## GC32 CLASS RULES 2018 - Questions and Answers No 3

These Q&A is given in accordance with the GC32 Class Rules 2018

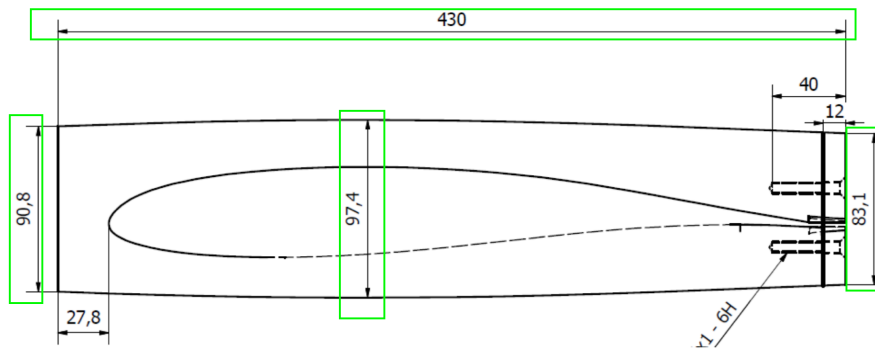
Are bottom bearings for boards delivered by TGC BV with dimensions outside of the building spec legal?

Point 3- should be read as following:

It is allowed to change the aft end disk with same or different material, but external dimensions of the bearing should be respected (thickness of back plate in sketch is informative).

In order to respect the external dimensions of the bearing the back of the cylinder may be further 'chopped' to fit a back plate of maximum 15mm thickness.

It is not allowed to change the position of the leading edge to the front end of the bearing.

#### Question 5:

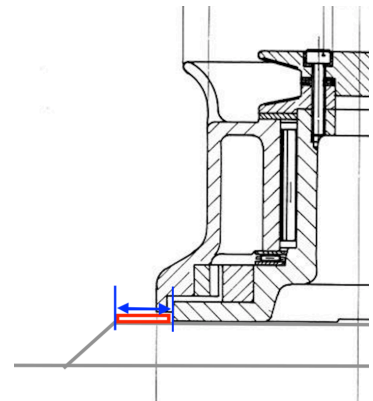
Is it allowed to install a ring around the main winches to prevent the sheet to be stacked under the winch?

It is allowed to glue a ring of maximum 5mm height of any material around the base of the jib winch, as long as the added material does not go under the base of the winch and does not extend further than the flat upper side of the plinth.
